Access Compliance Report

Public Rights-of-Way

Intersection ID: 10016341	Main Street: UNIVERSITY_CITY_BV	Cross Street: N/A	Location: NW
ADA ID: AC1D6E4F1676	Ramp Type: Directional1	Initial Pass/Fail: Pass	Overall Compliance: No
		Severity Score: 17.5

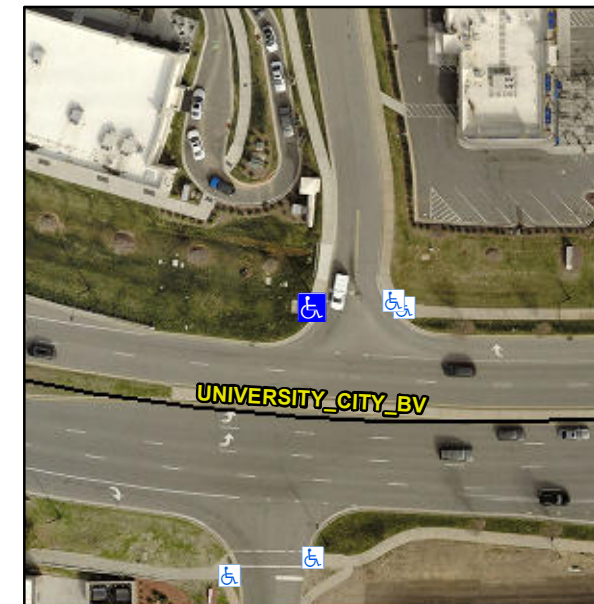
NO LNDG

R304.2.1, R304.2.2-Perp, R304.3.2-Para, R304.5.3, R304.2.3, R305.1.4, R305.2

Remove & Replace Entire Ramp.
